Service Update

17339 Incorrect Spare Wheel Assembly Installed

Reference Number: N172108840

Release Date: September 2017
Revision: 00

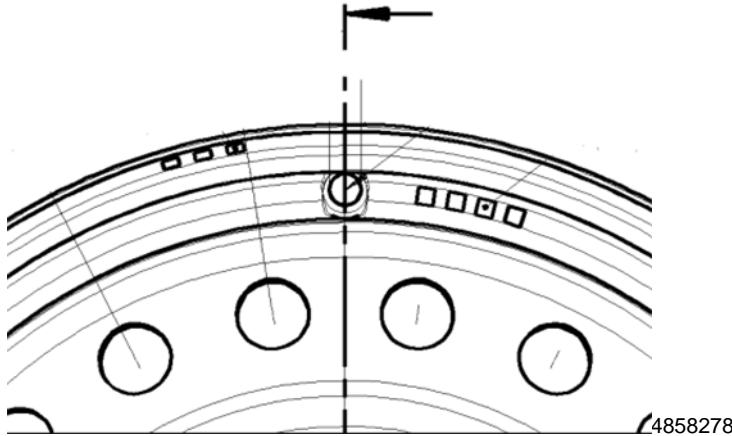
2. Find the bar code label on the tread of the tire. Using the information on the bar code, verify the vehicle is equipped with the correct spare wheel/tire assembly.
 - If the correct wheel/tire assembly is installed in the vehicle, no further action is required.
 - If the incorrect wheel/tire is installed, replace the spare wheel (reuse the existing tire). Refer to *Tire Dismounting and Mounting* in SI.
3. Reinstall the rear compartment components as necessary.

Chevrolet Impala tire sticker number ends with 5015

Buick LaCrosse tire sticker number ends with 5141

Alternate Wheel Identification Procedure

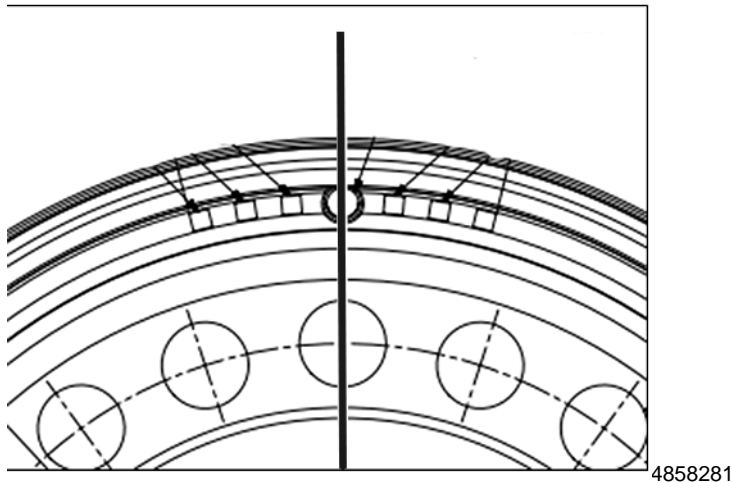
If the spare tire bar code label is missing or not readable, use the following wheel identification graphics to determine if the correct wheel/tire assembly is installed in the vehicle.

Chevrolet Impala valve stem located between holes in wheel

Buick LaCrosse valve stem aligned with hole in wheel
